SUBJECT: COMANCHE PEAK NUCLEAR POWER PLANT (CPNPP)
DOCKET NOS. 50-445 AND 50-446,
LICENSE AMENDMENT REQUEST (LAR) 12-06, REVISION TO TECHNICAL
SPECIFICATIONS 3.7.16, "FUEL STORAGE POOL BORON CONCENTRATION," 3.7.17,
"SPENT FUEL ASSEMBLY STORAGE" AND 5.5 "PROGRAMS AND MANUALS"

ATTACHMENT 1 to TXX-13001
DESCRIPTION AND ASSESSMENT

Figure 3.7.17-1 (page 1 of 1)
Fuel Assembly Burnup vs. U-235 Enrichments vs. Decay Time Limits
For a 4 out of 4 Storage Configuration in Region II Racks

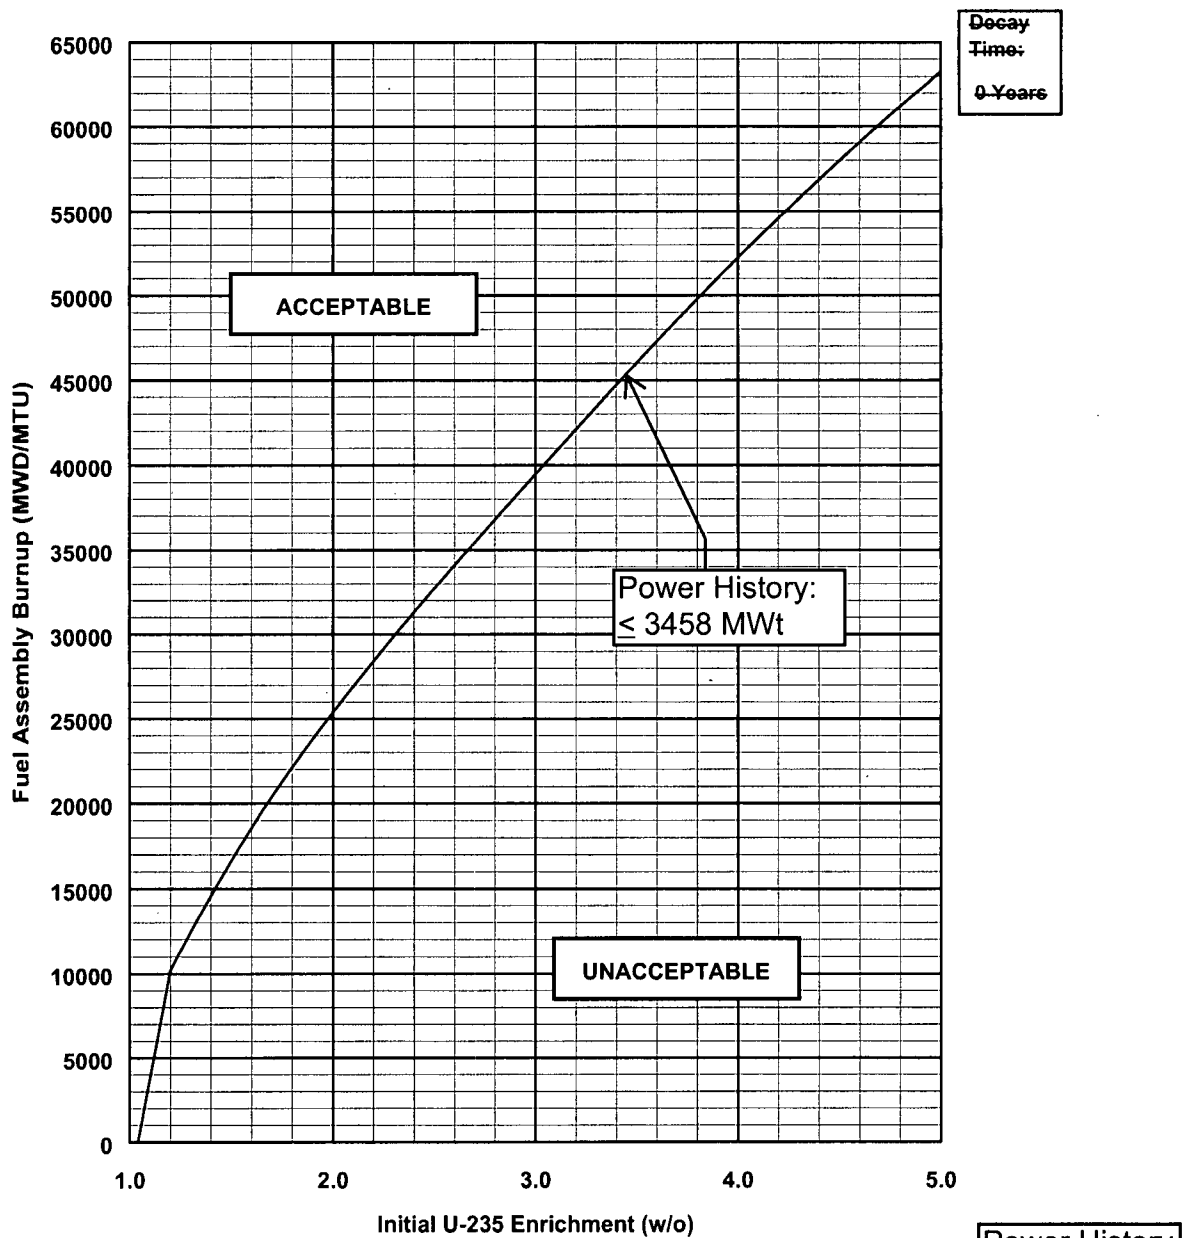
Revise LCO 3.7.17, SR 3.7.17.1, Figure 3.7.17-1 to remove unused reference to decay time and included power history reference. Revise Figure 3.7.17-2 to remove unused reference to decay time and included power history reference and include curve for fuel exposed above 3458 MWt. Revise Figure 3.7.17-3 to include power history.

The combination of initial enrichment, burnup and ~~decay time~~ ^{power history} of each spent fuel assembly stored in Region II racks shall be within either (1) the "acceptable" domain of Figure 3.7.17-1 in a 4 out of 4 configuration, (2) the "acceptable" domain of Figure 3.7.17-2 in a 3 out of 4 configuration, (3) the "acceptable" domain of Figure 3.7.17-3 in a 2 out of 4 configuration, or (4) shall be stored in a 1 out of 4 configuration. The acceptable storage configurations are shown in Figure 3.7.17-4.

Figure 3.7.17-2 (page 1 of 1)
Minimum Burnup vs. Initial U-235 Enrichment vs. Decay Time
For a 3 out of 4 Storage Configuration in Region II Racks

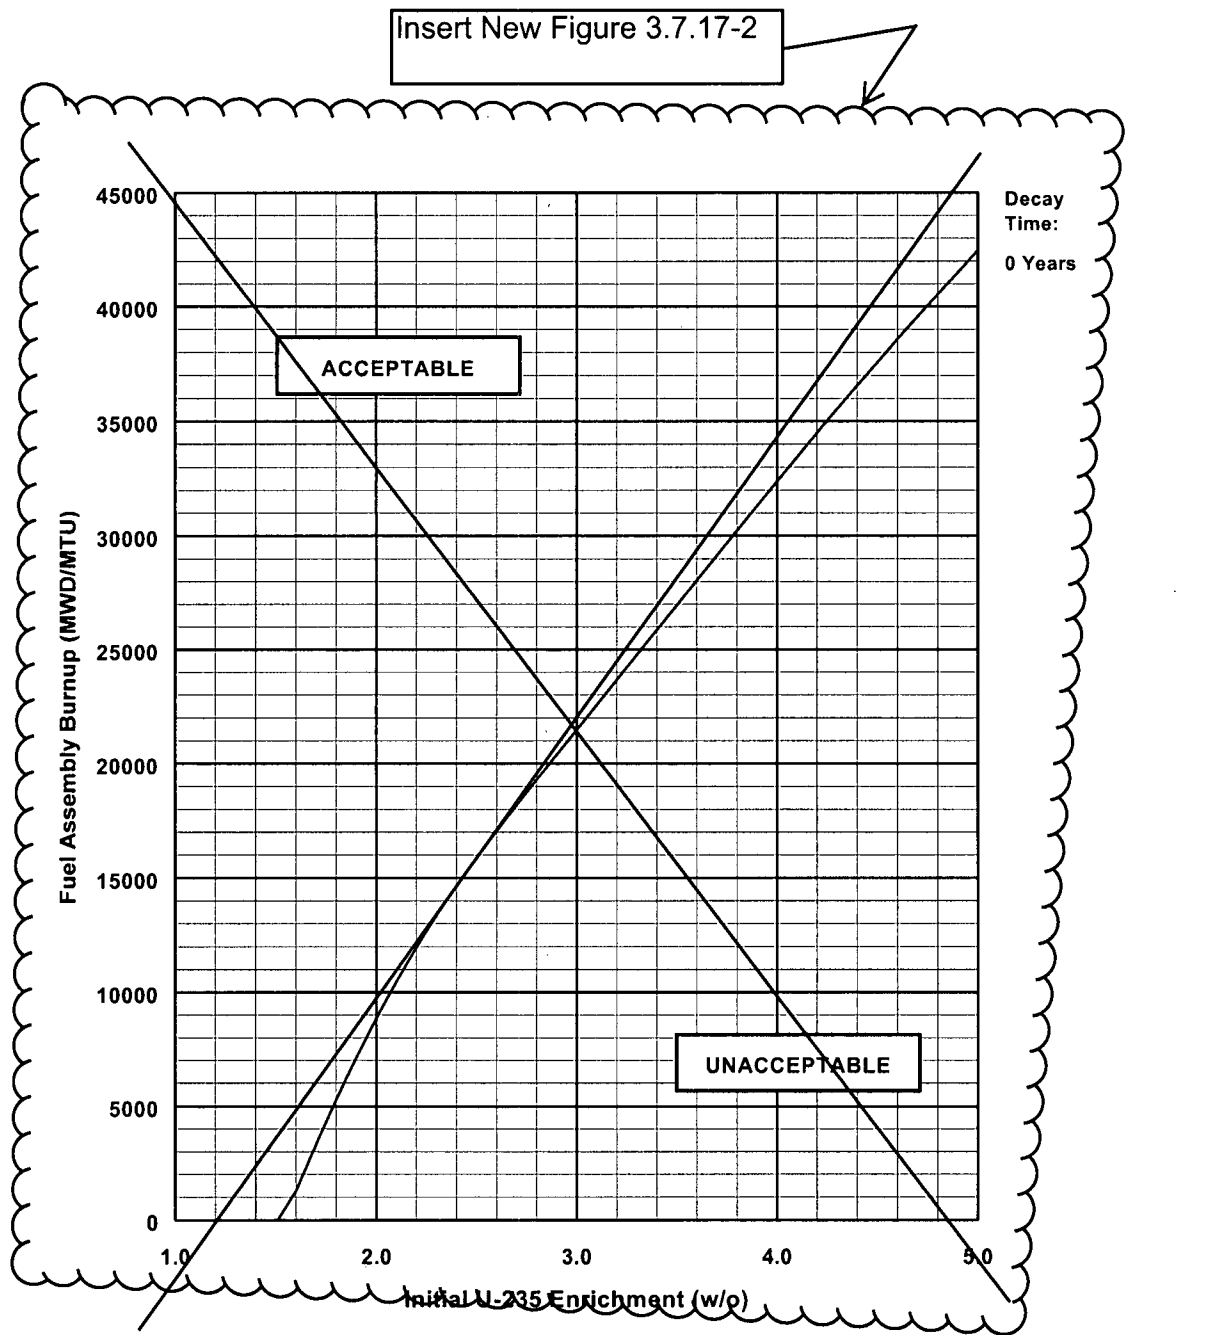
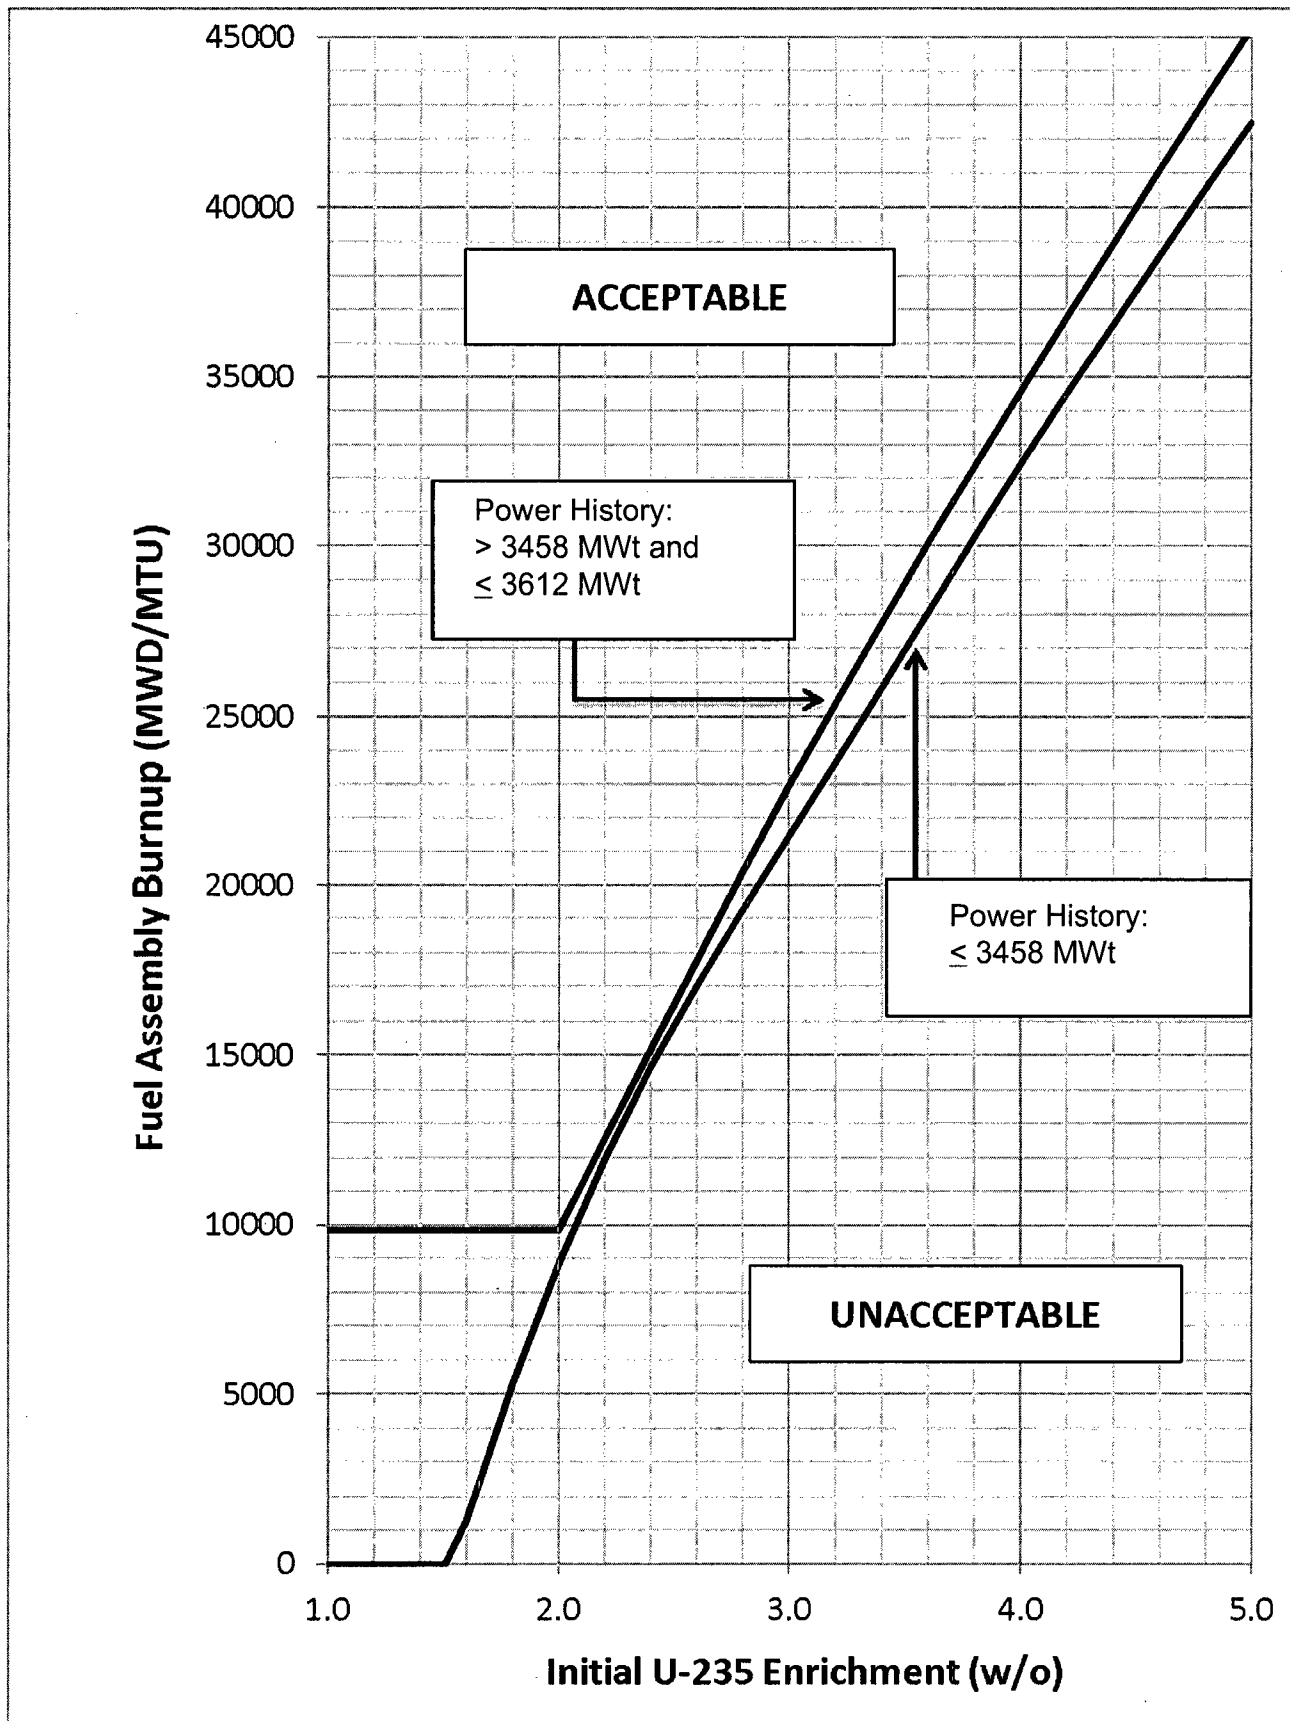
Using this methodology, a revised burnup versus enrichment curve was developed for the "3 out of 4" storage configuration, which supports the proposed revision to Figure TS 3.7.17-2. Revised burnup limits for the "4 out of 4" and "2 out of 4" cases are not included in this submittal. Therefore TS Figures 3.7.17-1 (4 out of 4 storage) is being revised to prohibit storage of fuel operated at uprate conditions and allow storage of fuel only if it operated at a power equal or less than 3458 MWt, and TS Figures 3.7.17-3 (2 out of 4 storage) is being revised to only allow storage of uprate fuel when the limits of 3.7.17-2 (3 out of 4 storage) are satisfied.

Power History Limits

New Figure 3.7.17-2

Figure 3.7.17-3 (page 1 of 1)
Minimum Burnup vs. Initial U-235 Enrichment
For a 2 out of 4 Storage Configuration in Region II Racks

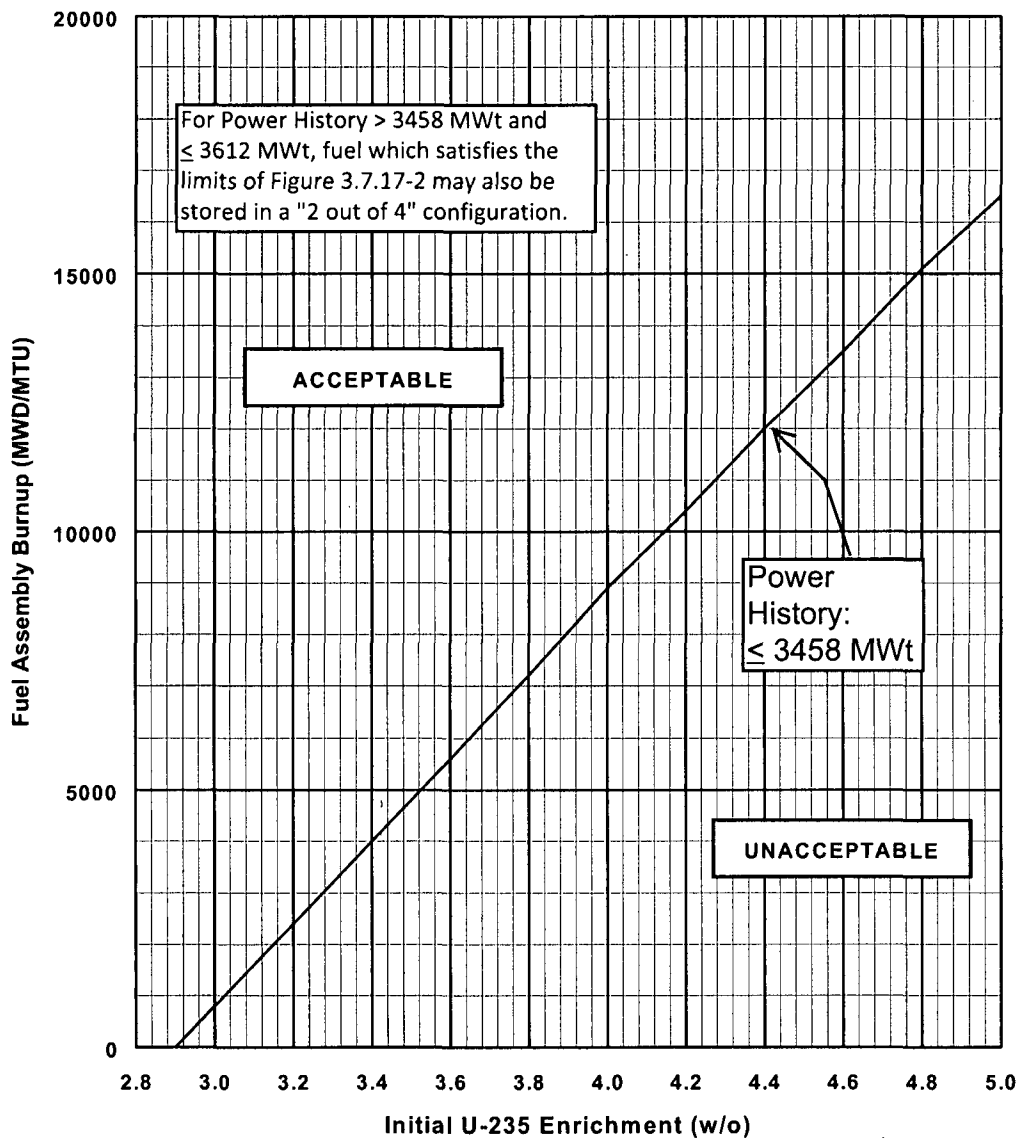
vs. Power History Limits

Figure 3.7.17-1 (page 1 of 1)
Fuel Assembly Burnup vs. U-235 Enrichments vs. Power History Limits
For a 4 out of 4 Storage Configuration in Region II Racks

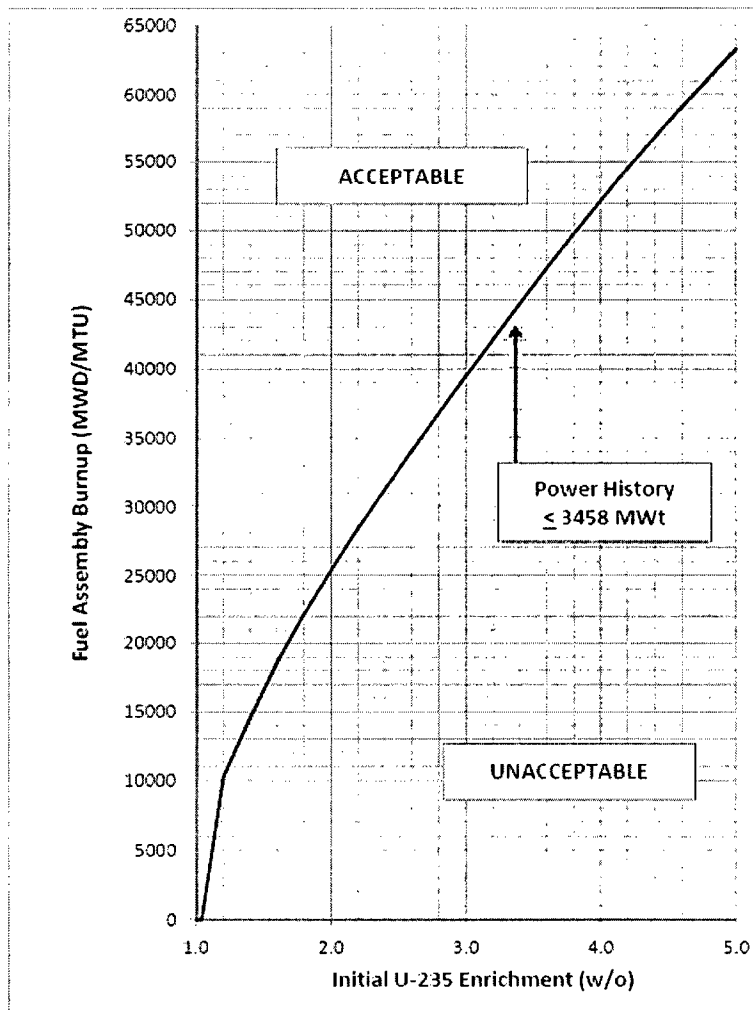
The “Power History” requirements associated with Figure 3.7.17-1, Figure 3.7.17-2, and Figure 3.7.17-3 refer to the highest value of Rated Thermal Power for any fuel cycle which contained the assembly. Figure 3.7.17-1 only contains a limit associated with a Power History ≤ 3458 MWt. This limits fuel assemblies which have been depleted in a fuel cycle with a Rated Thermal Power higher than 3458 MWt to a less dense storage configuration. Figure 3.7.17-3 only contains a burnup limit curve associated with a Power History ≤ 3458 MWt, but includes a note explaining that fuel with Power History ≤ 3612 MWt may be stored in “2 out of 4” if the limits of Figure 3.7.17-2 are satisfied. Therefore, fuel which has been depleted with a Rated Thermal Power higher than 3458 MWt must satisfy the limitations for “3 out of 4” storage to be stored in either a “2 out of 4” or “3 out of 4” configuration.
